# 2022 EDITION

## LOS ANGELES REGIONAL UNIFORM CODE PROGRAM

Recommended Code Amendments to  
the 2022 Edition of the California  
Building Code, California Residential  
Code, and California Green Building  
Standards Code.

Final Version: 07-01-22

**FIGURE 1809.3**  
**STEPPED FOOTING**

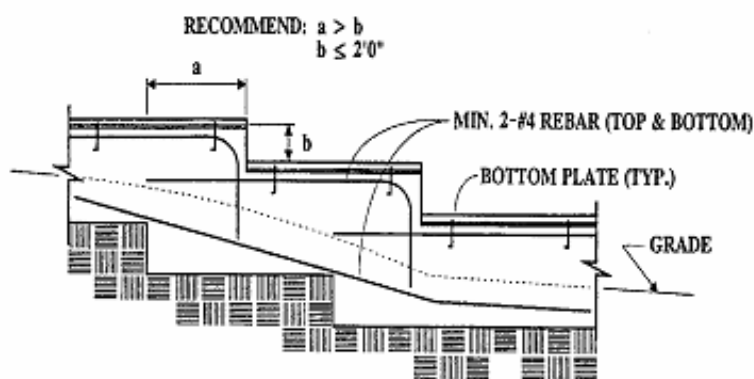
Section 1809.3 of the 2022 Edition of the California Building Code is amended to read as follows:

**1809.3 Stepped footings.** The top surface of footings shall be level. The bottom surface of footings shall be permitted to have a slope not exceeding one unit vertical in 10 units horizontal (10-percent slope). Footings shall be stepped where it is necessary to change the elevation of the top surface of the footing or where the surface of the ground slopes more than one unit vertical in 10 units horizontal (10-percent slope).

For structures assigned to Seismic Design Category D, E or F, the stepping requirement shall also apply to the top surface of continuous footings supporting walls. Footings shall be reinforced with four No. 4 deformed reinforcing bars. Two bars shall be placed at the top and bottom of the footings as shown in Figure 1809.3.

**FIGURE 2308.6.5.1  
ALTERNATE BRACED WALL PANEL (ABW)**

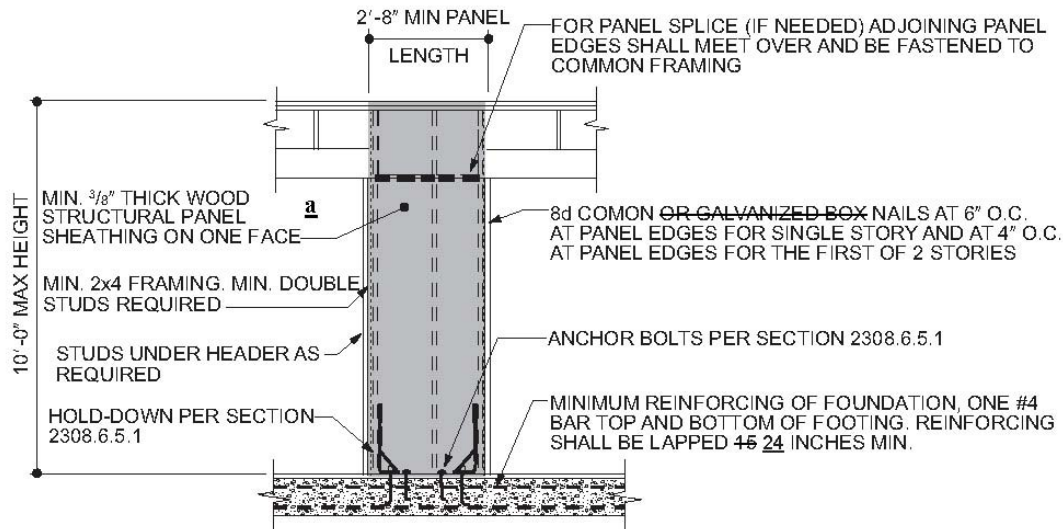
Sections 2308.6.5.1 and 2308.6.5.2 and Figures 2308.6.5.1 and 2308.6.5.2 of the 2022 Edition of the California Building Code are amended to read as follows:

**2308.6.5.1 Alternate braced wall (ABW).** An ABW shall be constructed in accordance with this section and Figure 2308.6.5.1. In one-story buildings, each panel shall have a length of not less than 2 feet 8 inches (813 mm) and a height of not more than 10 feet (3048 mm). Each panel shall be sheathed on one face with 3/8-inch (3.2 mm) minimum-thickness wood structural panel sheathing nailed with 8d common or galvanized box nails in accordance with Table 2304.10.1 and blocked at wood structural panel edges. For structures assigned to Seismic Design Category D or E, each panel shall be sheathed on one face with 15/32-inch-minimum-thickness (11.9 mm) wood structural panel sheathing nailed with 8d common nails spaced 3 inches on panel edges, 3 inches at intermediate supports. Two anchor bolts installed in accordance with Section 2308.3.1 shall be provided in each panel. Anchor bolts shall be placed at each panel outside quarter points. Each panel end stud shall have a hold-down device fastened to the foundation, capable of providing an approved uplift capacity of not less than 1,800 pounds (8006 N). The hold-down device shall be installed in accordance with the manufacturer's recommendations. The ABW shall be supported directly on a foundation or on floor framing supported directly on a foundation that is continuous across the entire length of the braced wall line. This foundation shall be reinforced with not less than one No. 4 bar top and bottom. Where the continuous foundation is required to have a depth greater than 12 inches (305 mm), a minimum 12-inch by 12-inch (305 mm by 305 mm) continuous footing or ~~turned-down slab edge~~ is permitted at door openings in the braced wall line. This continuous footing or ~~turned-down slab edge~~ shall be reinforced with not less than one No. 4 bar top and bottom. This reinforcement shall be lapped ~~45~~ 24 inches (384 610 mm) with the reinforcement required in the continuous foundation located directly under the braced wall line.

Where the ABW is installed at the first story of two-story buildings, the wood structural panel sheathing shall be provided on both faces, three anchor bolts shall be placed at one-quarter points and tie-down device uplift capacity shall be not less than 3,000 pounds (13 344 N).

**FIGURE 2308.6.5.2**  
**PORTAL FRAME WITH HOLD-DOWNS (PFH)**

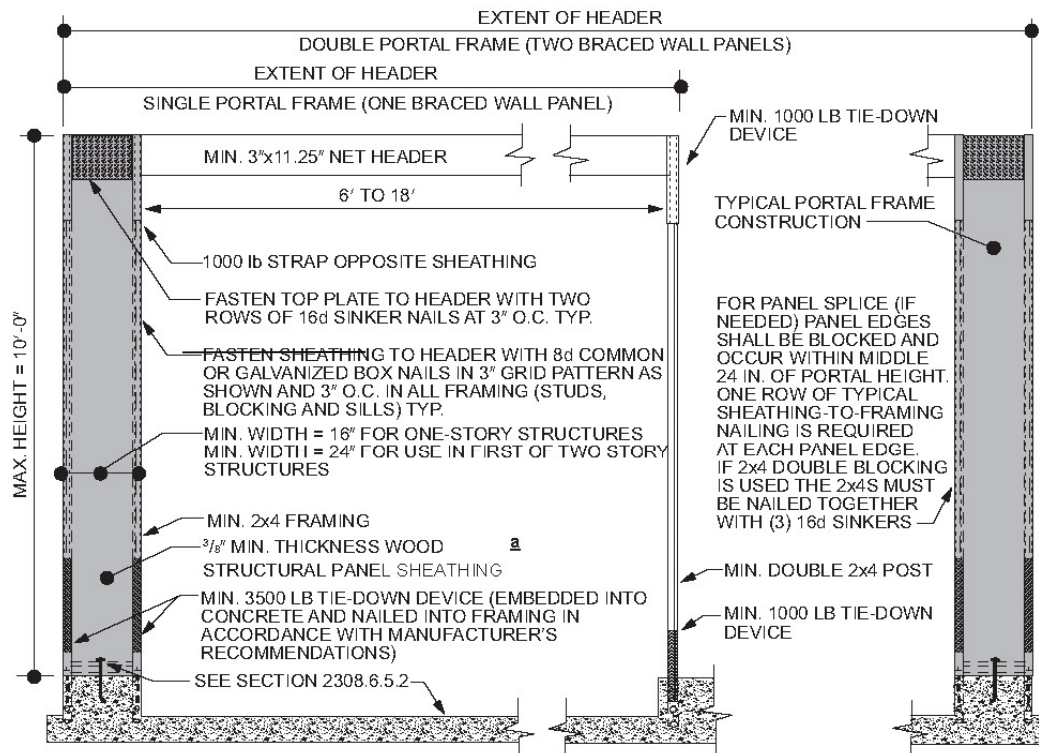
**2308.6.5.2 Portal frame with hold-downs (PFH).** A PFH shall be constructed in accordance with this section and Figure 2308.6.5.2. The adjacent door or window opening shall have a full-length header.

In one-story buildings, each panel shall have a length of not less than 16 inches (406 mm) and a height of not more than 10 feet (3048 mm). Each panel shall be sheathed on one face with a single layer of 3/8-inch (9.5 mm) minimum-thickness wood structural panel sheathing nailed with 8d common or galvanized box nails in accordance with Figure 2308.6.5.2. For structures assigned to Seismic Design Category D or E, each panel shall be sheathed on one face with 15/32-inch-minimum-thickness (11.9 mm) wood structural panel sheathing nailed with 8d

common nails spaced 3 inches on panel edges, 3 inches at intermediate supports and in accordance with Figure 2308.6.5.2. The wood structural panel sheathing shall extend up over the solid sawn or glued-laminated header and shall be nailed in accordance with Figure 2308.6.5.2. A built-up header consisting of at least two 2-inch by 12-inch (51 mm by 305 mm) boards, fastened in accordance with Item 26 of Table 2304.10.2 shall be permitted to be used. A spacer, if used, shall be placed on the side of the built-up beam opposite the wood structural panel sheathing. The header shall extend between the inside faces of the first full-length outer studs of each panel. The clear span of the header between the inner studs of each panel shall be not less than 6 feet (1829 mm) and not more than 18 feet (5486 mm) in length. A strap with an uplift capacity of not less than 1,000 pounds (4,400 N) shall fasten the header to the inner studs opposite the sheathing. One anchor bolt not less than 5/8 inch (15.9 mm) diameter and installed in accordance with Section 2308.3.1 shall be provided in the center of each sill plate. The studs at each end of the panel shall have a hold-down device fastened to the foundation with an uplift capacity of not less than 3,500 pounds (15 570 N).

**FIGURE 3115.8.5.3(1)**  
**Bracing Unit Distribution – Maximum Linear Length**

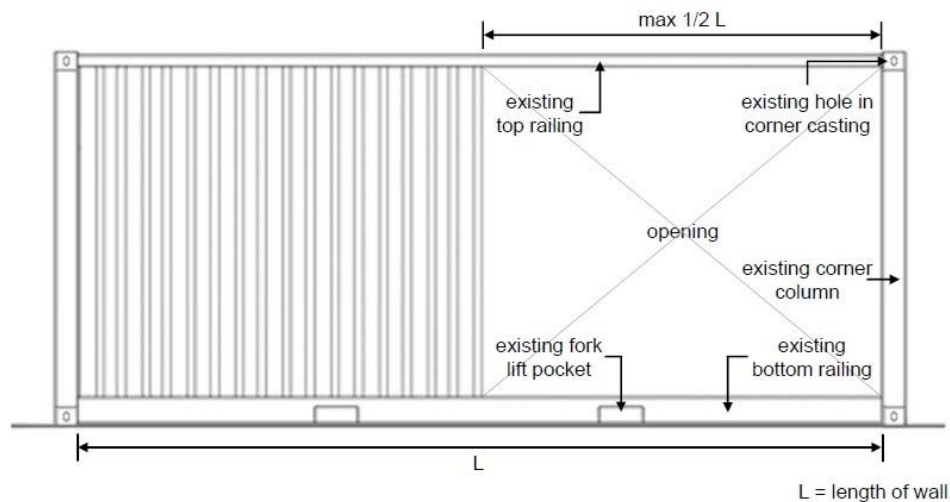
1. The total linear length of all openings in any individual side walls or end walls shall be limited to not more than 50 percent of the length of that side walls or end walls, as shown in Figure 3115.8.5.3(1).

**FIGURE 3115.8.5.3(2)**  
**Bracing Unit Distribution – Minimum Linear Length**

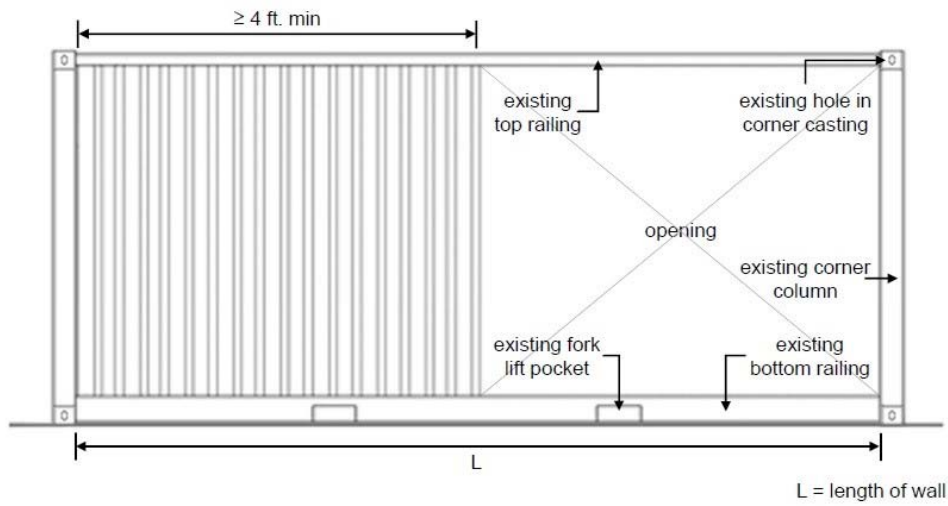
2. Any full height wall length, or portion thereof, less than 4 feet (305 mm) long shall not be considered as a portion of the lateral force-resisting system, as shown in Figure 3115.8.5.3(2).

**FIGURE 3115.8.5.3(3)**  
**Bracing Unit Distribution – Boundary Elements**

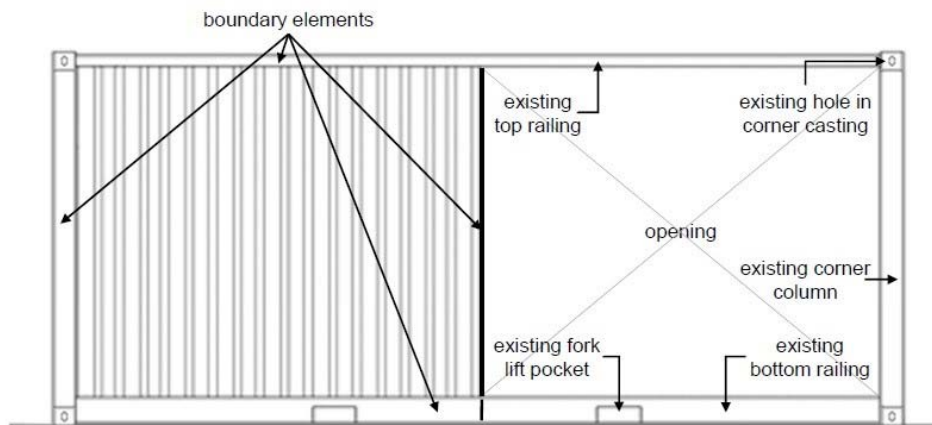
3. All side walls or end walls used as part of the lateral force-resisting system shall have an existing or new boundary element on all sides to form a continuous load path, or paths, with adequate strength and stiffness to transfer all forces from the point of application to the final point of resistance, as shown in Figure 3115.8.5.3(3). The existing door interlocking mechanism shall not be considered as a component of the required load path.

**FIGURE R403.1.5  
STEPPED FOOTING**

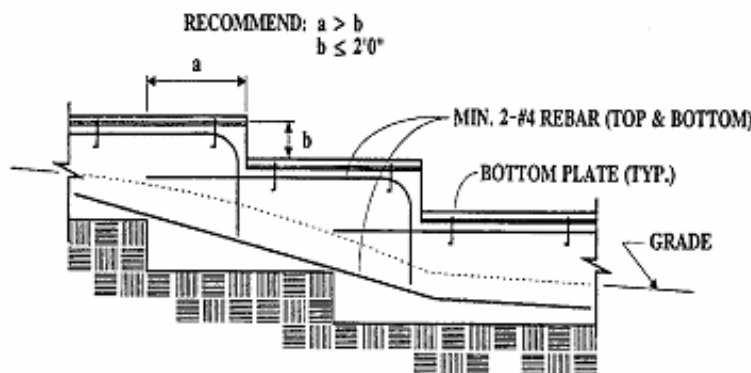
**R403.1.5 Slope.** The top surface of footings shall be level. The bottom surface of footings shall not have a slope exceeding one unit vertical in 10 units horizontal (10-percent slope). Footings shall be stepped where it is necessary to change the elevation of the top surface of the footings or where the slope of the bottom surface of the footings will exceed one unit vertical in 10 units horizontal (10-percent slope).

For structures assigned to Seismic Design Categories D<sub>0</sub>, D<sub>1</sub> or D<sub>2</sub>, stepped footings shall be reinforced with four No. 4 rebar. Two bars shall be placed at the top and bottom of the footings as shown in Figure R403.1.5.

**FIGURE R602.10.6.1  
METHOD ABW—ALTERNATE BRACED WALL PANEL**

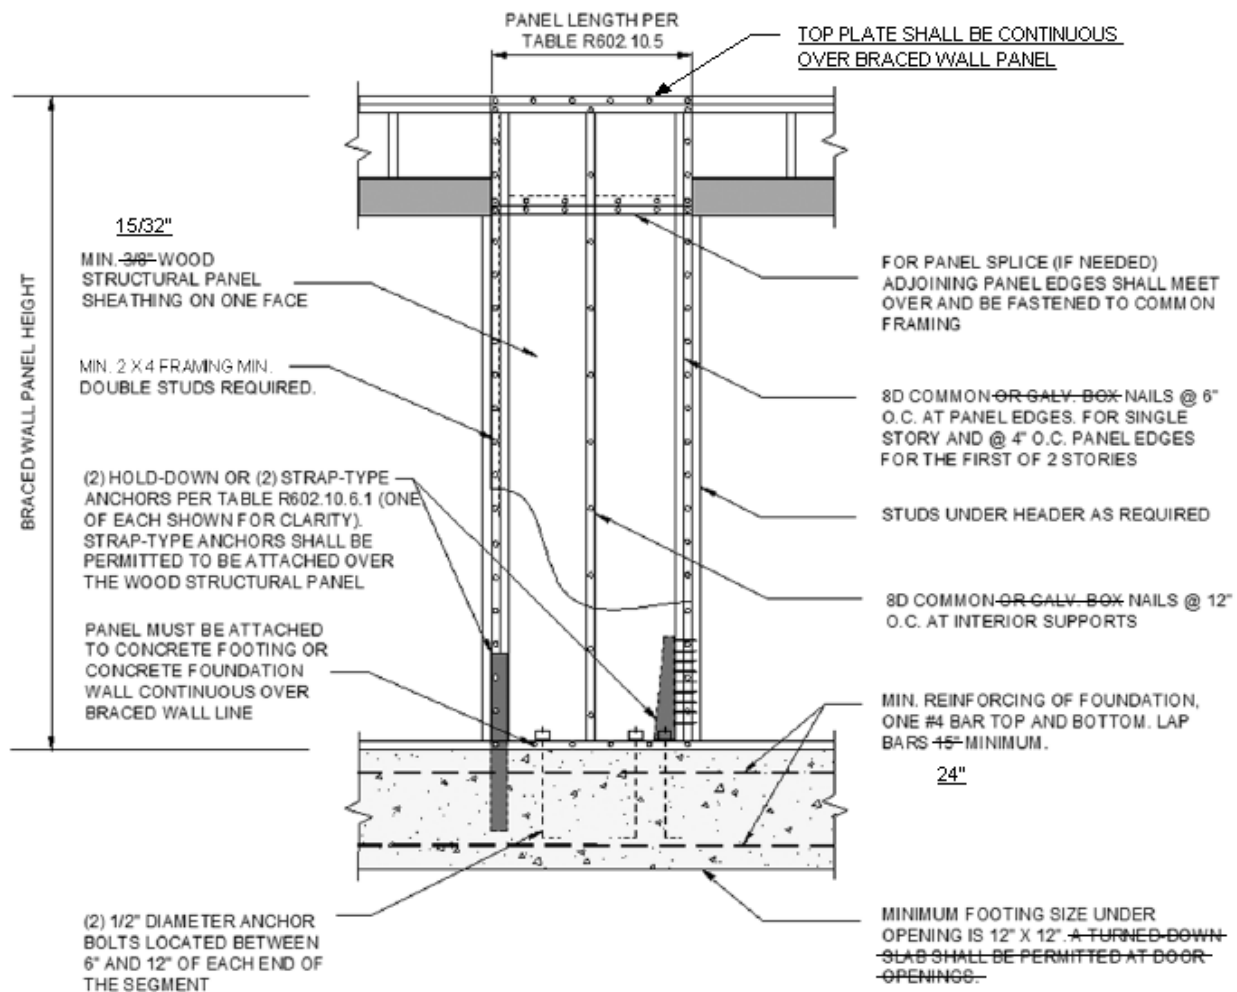
## 2022 LARUCP R6-08

Figure R602.10.6.1 of the 2022 Edition of the California Residential Code is amended to read as follows:

**FIGURE R602.10.6.2**  
**METHOD PFH—PORTAL FRAME WITH HOLD-DOWNS**  
**AT DETACHED GARAGE DOOR OPENINGS**

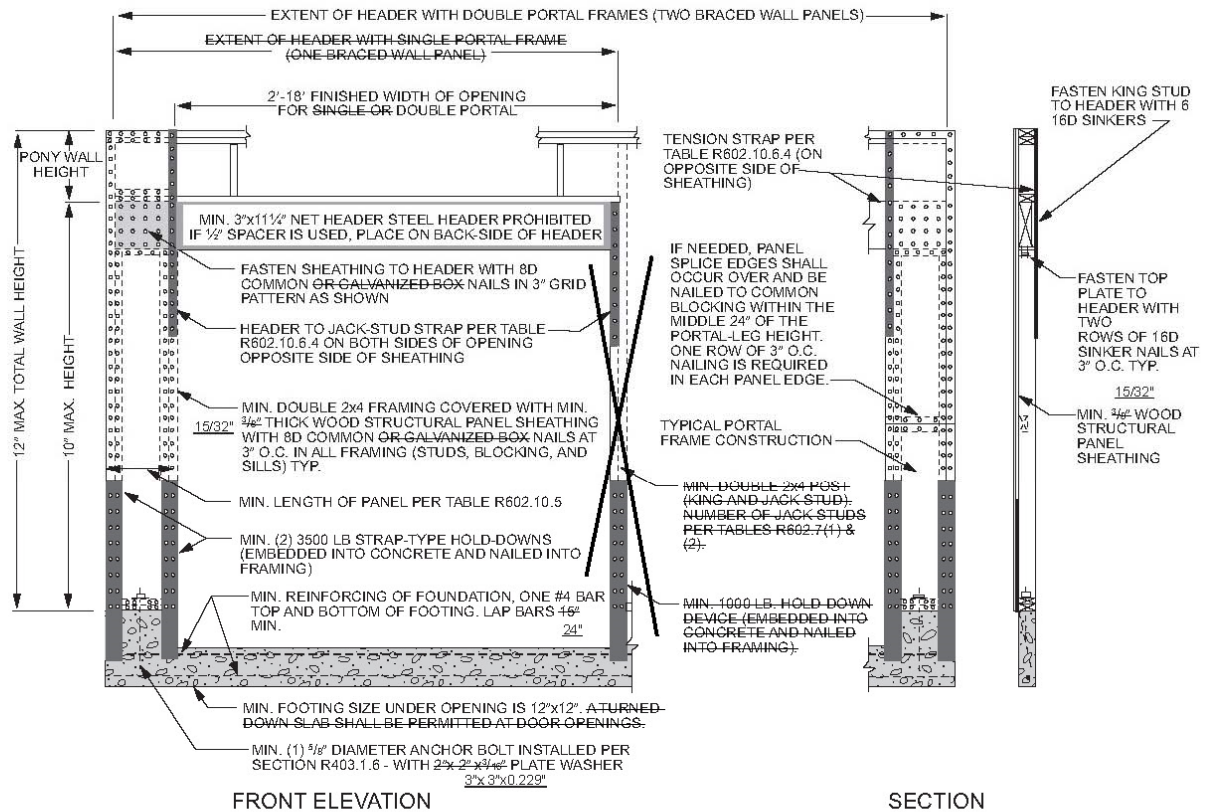
## 2022 LARUCP R6-09

Figure R602.10.6.2 of the 2022 Edition of the California Residential Code is amended to read as follows:

**FIGURE R602.10.6.4**  
**METHOD CS-PF—CONTINUOUSLY SHEATHED PORTAL FRAME PANEL CONSTRUCTION**

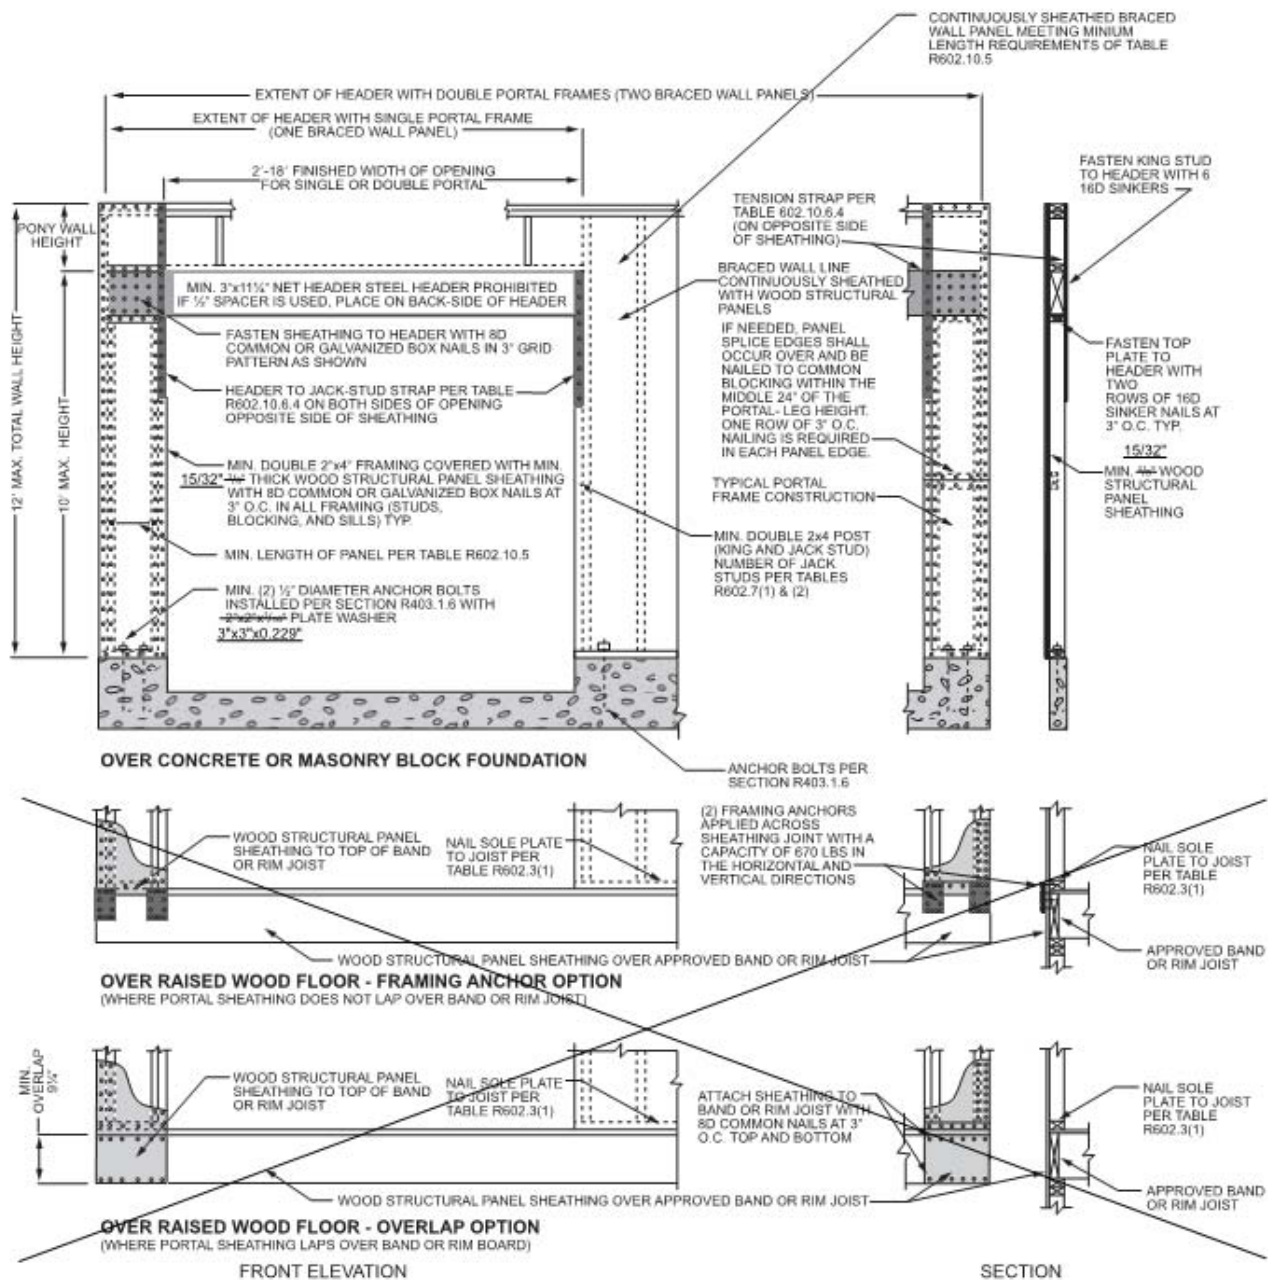
## 2022 LARUCP R6-10

Figure R602.10.6.4 of the 2022 Edition of the California Residential Code is amended to read as follows:
